UNITED STATES PATENT AND TRADEMARK OFFICE

APPLICATION NO.	FILING DATE	FIRST NAMED INVENTOR	ATTORNEY DOCKET NO.	CONFIRMATION NO.
09/769,727	01/26/2001	Robert J. Ein	035887-0106	5192

Office Action Summary

DETAILED ACTION

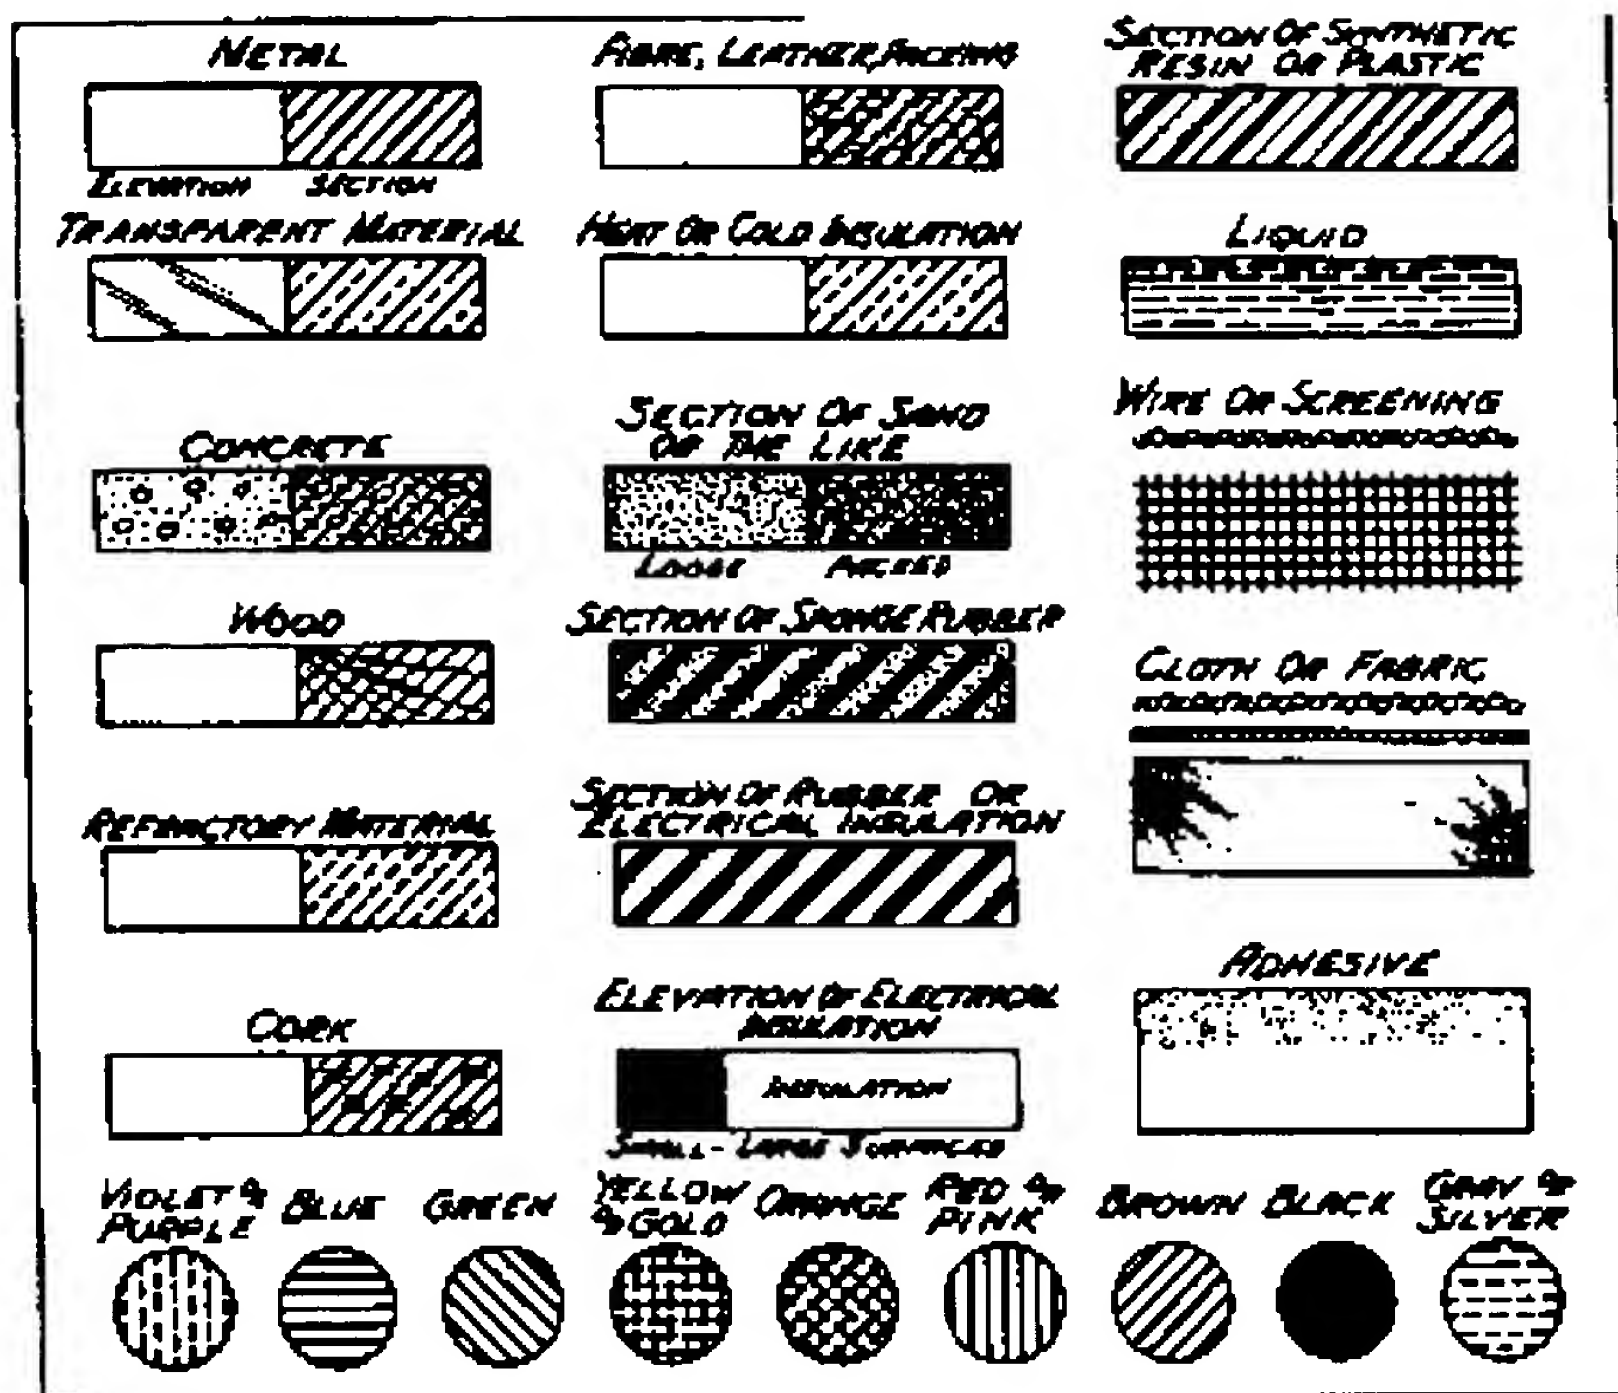
The drawings are objected to because of the following informalities:

Fig. 4A-4E: Proper cross-sectional hatching is required to properly denote *insulative and metallic* materials in accordance with MPEP 608.02 (see the drawing below for proper hatching examples).

The response to this action must include a separate letter addressed to the examiner and contain: (1) sketches showing in red the drawing changes required above and (2) a request that the examiner approve the changes as shown on the sketches.
